Amendments to the Drawings

Please consider the attached proposed replacement drawing sheet 2.

FIG. 2

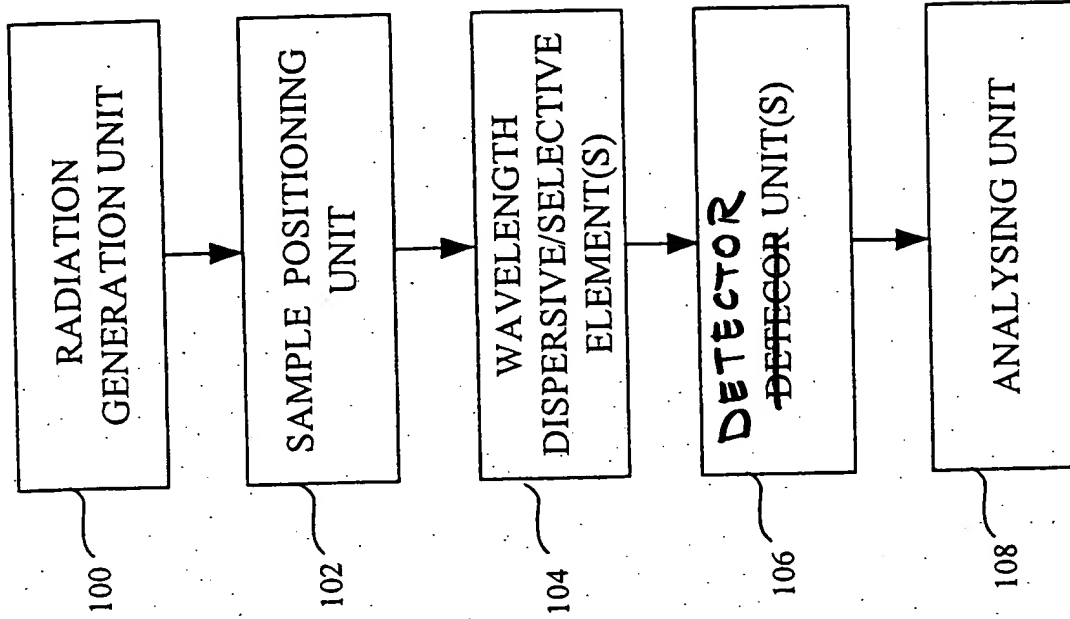
The attached sheet of drawings, comprising Figures 1b and 2, is presented as a proposed replacement sheet for drawing sheet 2 as originally filed. This sheet includes a proposed amendment to Figure 2. In Figure 2, the spelling of the word "DETECOR" has been corrected to read "DETECTOR". Support for the correction is provided by the specification at page 9, lines 4-5.
